DART AEROSPACE LTD	Work Order:	97936
Description: Crosstube High Aft (412)	Part Number:	D412-664-203
Inspection Dwg: D412-664-243	Rev: E	Page 1 of 1

CROSSSTUBE ASSEMBLY (412 HI AFT)

DRAWING NO. D412-664-243	TITLE CROSSTUBE ASS'Y (412 HI AFT)	REV. E	DART AEROSPACE LTD ENGINEERING ORDER		D.E.O. NO. D412-664-243-E-2	SHEET NO. SHEET 1 OF 1	SCALE NTS
DRAWN 90	CHECKED ASS	MFG. APPR. E	APPROVED MP		DE APPR. H		
DATE 11.09.07	DATE 11.09.19	DATE 11.09.19	DATE 11.09.19		DATE 11.09.19

DRAWING NO. D412-664-243	TITLE CROSSTUBE ASSEMBLY (412 HI AFT)	REV. E	DART AEROSPACE LTD ENGINEERING ORDER		D.E.O. NO. D412-664-243-E-4	SHEET NO. SHEET 1 OF 3	SCALE NTS
DRAWN 9	CHECKED A	MFG. APPR. A	APPROVED MP		DE APPR. MP		
DATE 12.08.21	DATE 12.08.30	DATE 12.08.30	DATE 12/8/30		DATE 12.08-30

**D412-664-243
ASSEMBLY DETAIL**

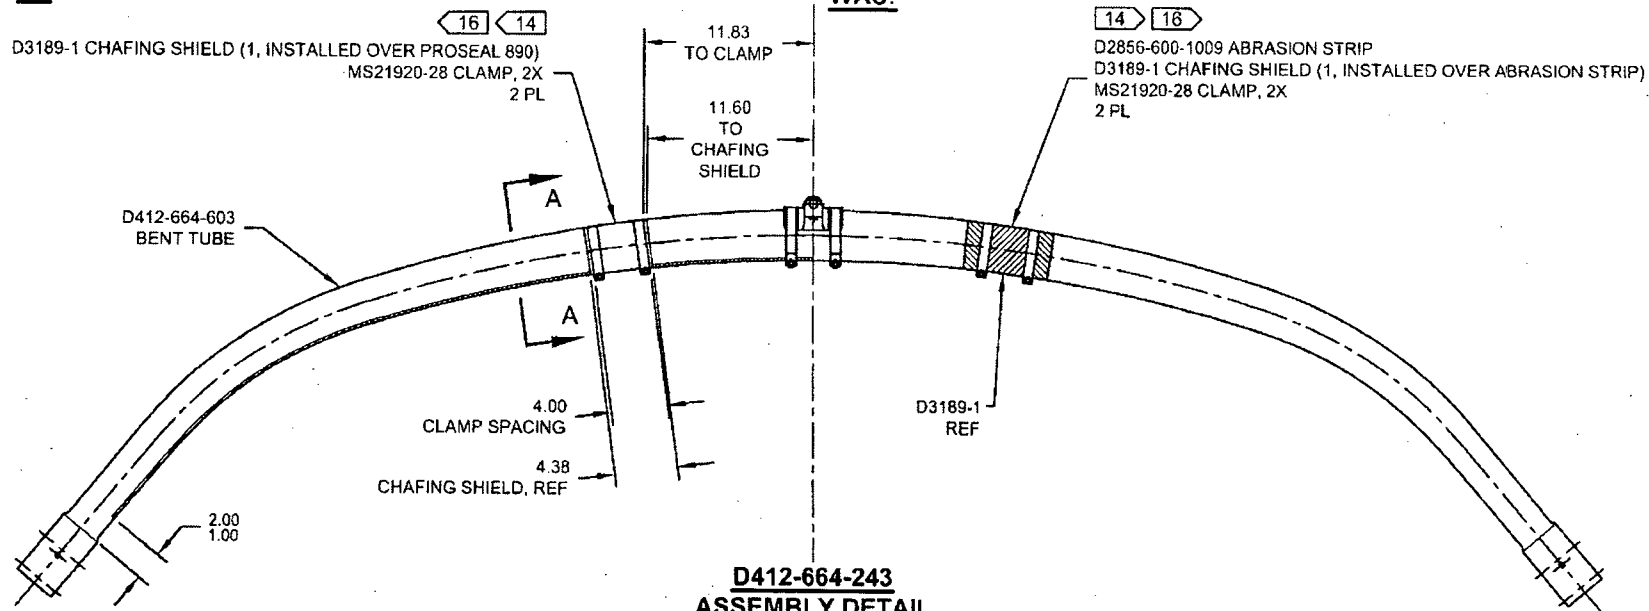
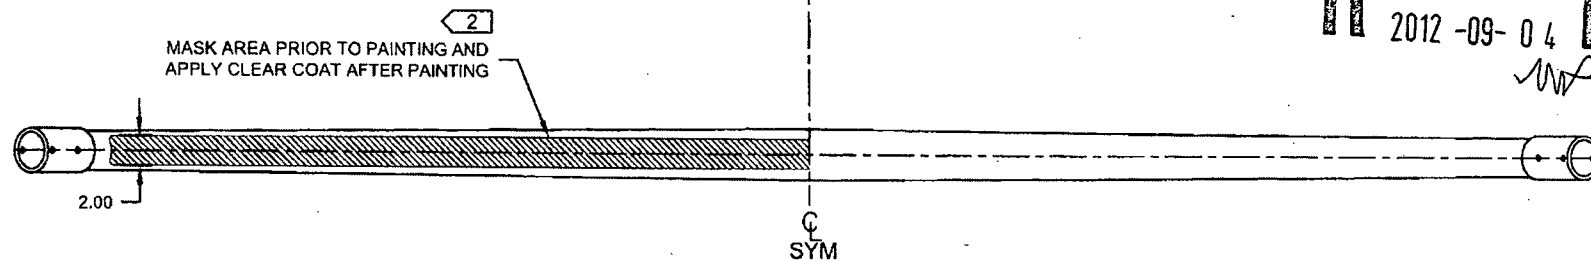
REMOVED ABRASION STRIP IN FAVOR OF A THIN LAYER OF PROSEAL 890. UPDATE INSTALLATION OF CHAFING SHIELDS AND REDUCE TORQUE TO 40-50 IN-LBS. THIS ENGINEERING ORDER SUPERCEDES DEO D412-664-243-E-1.

IS:

D3189-1 CHAFING SHIELD (1, INSTALLED OVER PROSEAL 890)
MS21920-28 CLAMP, 2X
2 PL

WAS:

D2856-600-1009 ABRASION STRIP
D3189-1 CHAFING SHIELD (1, INSTALLED OVER ABRASION STRIP)
MS21920-28 CLAMP, 2X
2 PL
